St. Elmo Apartments, Sketch Plan Amendment No. 32015004A & Preliminary Plan Amendment No. 12015020A

Completed: 10/01/2018

Figure 4: Proposed Sketch Plan

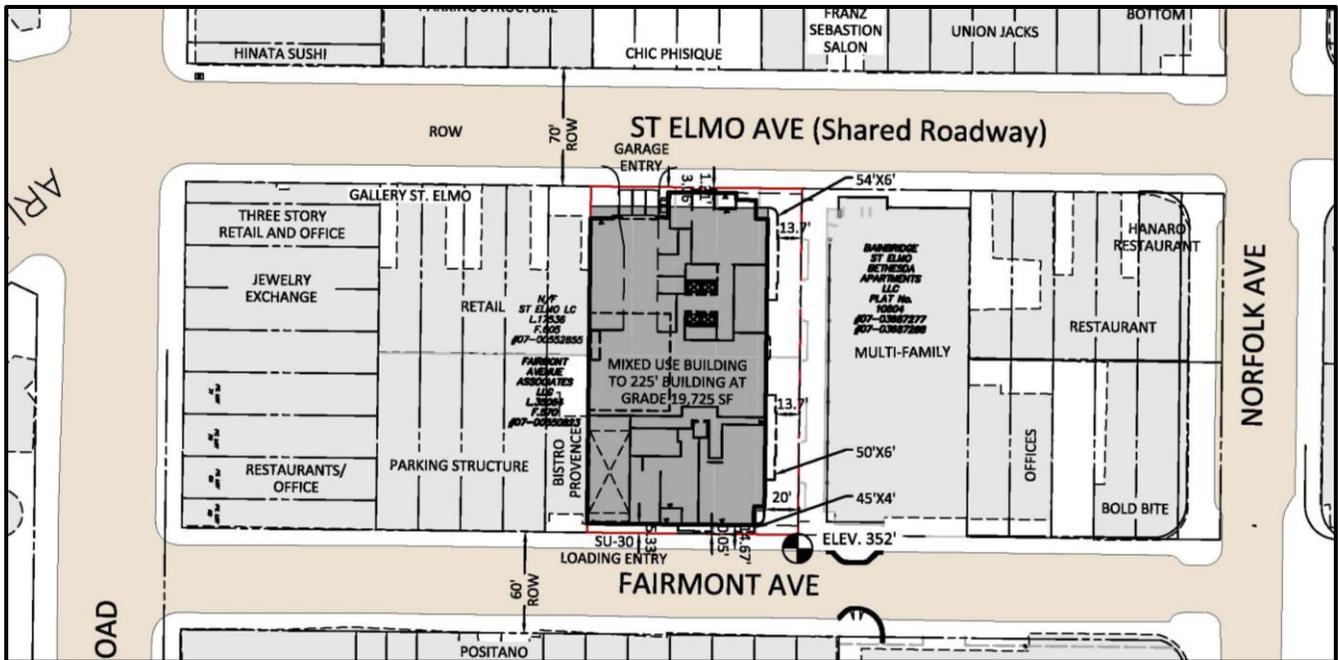
Staff has raised these issues with the Applicant and the Design Advisory Panel. The Design Advisory Panel remains split on their recommendation after two meetings with the Applicant (See Attachment F). Some members state that while the tower separation is less than preferred, the building is well designed and should move forward. Other members state that the building is well designed architecturally but the tower separation is too minimal to provide adequate light and air and needs to be moved back to provide tower step-backs as recommended by the Design Guidelines. Given the split recommendation from the Design Advisory Panel, Staff recommends minimum conformance with the side setback of 22.5' with the inclusion of step-backs after 70 feet in height, and the project move forward with the condition that the tower step-back be revisited at time of Site Plan review, and that alternatives be provided to the Design Advisory Panel showing tower step-backs for review and consideration.

Due to the Design Guidelines conformance issues raised in Finding 2 above, Staff recommended the Applicant return to the Design Advisory Panel for clarity on the recommendations of the first meeting regarding tower step-backs along the through block connection. At a meeting held on September 26, 2018, four DAP members were present. The discussion at this meeting waivered between whether or not the Project substantially conforms with the provisions of the Design Guidelines. The panel members questioned why the building could not be moved south to allow additional space between the proposed building and adjacent existing development. Two members stated that the building as proposed does not allow sufficient light and air into the through block connection for the residents of the upper floors. Other members stated that because the building is architecturally well designed, the Project should move forward as is.

Projects within the Bethesda Overlay Zone are required to achieve a minimum of 10 Exceptional Design points. The meeting resulted in 2 members voting in favor of being on track to meet these 10 points, while 2 were in support with conditions (greater tower separation, at least 10-15 feet). Due to this split decision, Staff supports the category at this time, and has recommended a condition to require alternatives be provided to the Design Advisory Panel for review at Site Plan, which includes tower step-backs. However, Staff is recommending that the applicant consider a step-back that meets the minimum recommendation of the Design Guidelines.

Provide alternatives for building design and placement along through block connection that utilize tower step-backs for review and consideration by the Design Advisory Panel.

Figure 7: Illustrative Public Open Space Concept

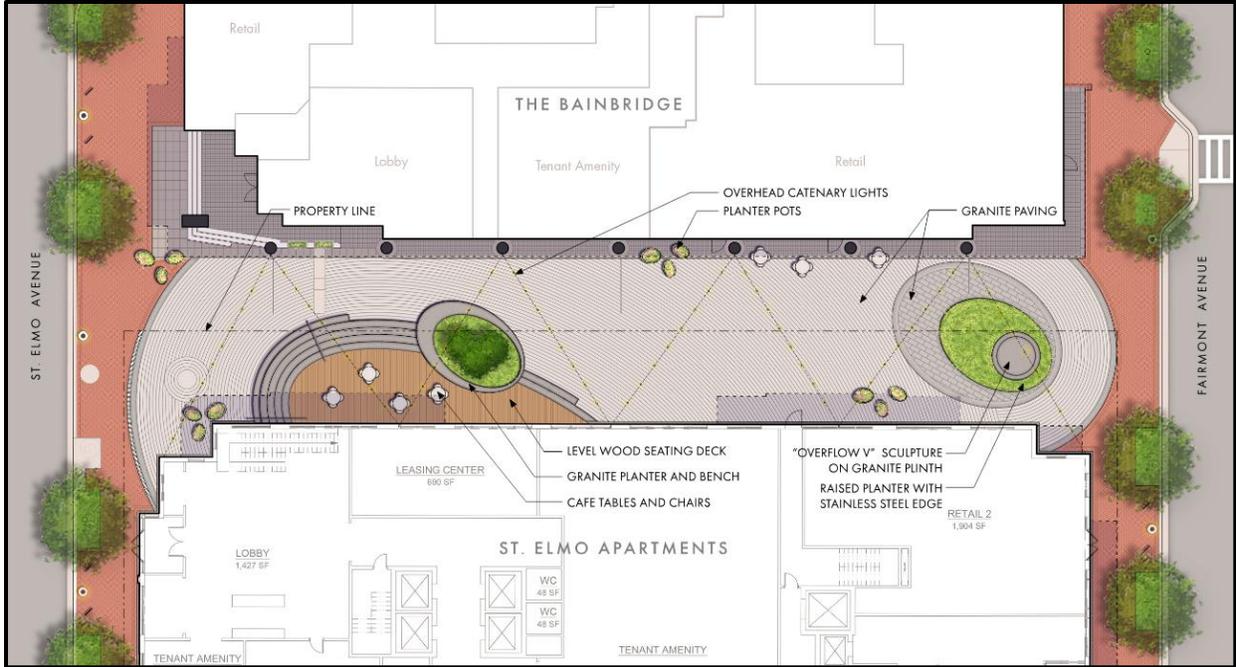
Conceptually, the design of the expanded through block connection will utilize a combination of site-specific art, benches, lighting and hardscape in addition to retail uses located on the ground floor to activate the passageway (Figure 7). The Applicant presented the public art concept as shown below (Figure 8) to the Art Review Panel on March 21, 2017. The existing through block connection contains a series of public art in the form of four large metal panels. The Art Review Panel had recommended the Applicant notify the Panel when a landing location for the decommissioned artwork has been chosen. Site Plan 820170030 was previously conditioned, Planning Board Resolution 17-031, to present the final public art concept to the Art Review Panel prior to certification of the Site Plan.
